Road & Bridge Design Publications

Monthly Update – May 2021

Revisions for the month of **May** are listed and displayed below and will be included in projects submitted for the **September** letting, except as specified below.

TYPICAL NON-FREEWAY SHOULDER CORRUGATION INSTALLATION

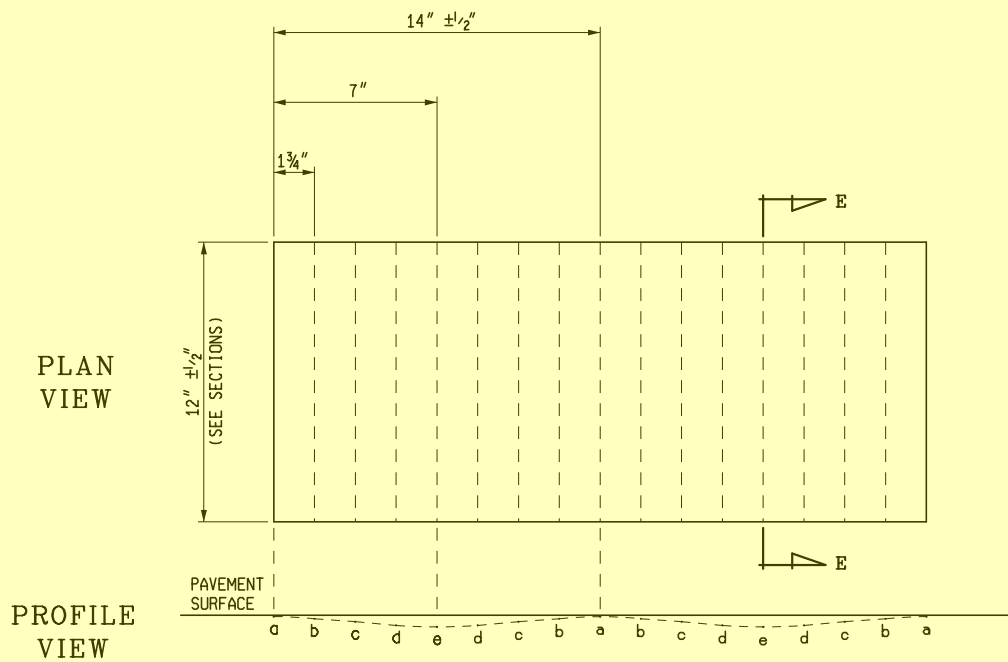
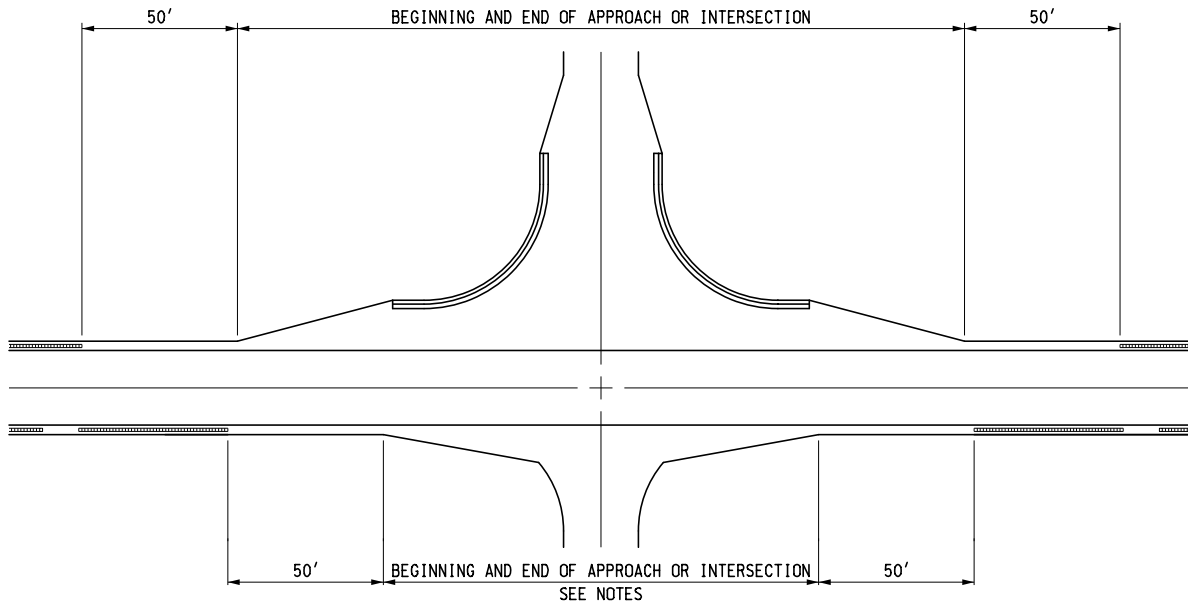
R-112-J: Shoulder and Center Line Corrugations: Eliminated the use of standard corrugations for non-freeway shoulders and added details to replace them (sinusoidal corrugations/mumble strips).

SINUSOIDAL CORRUGATIONS
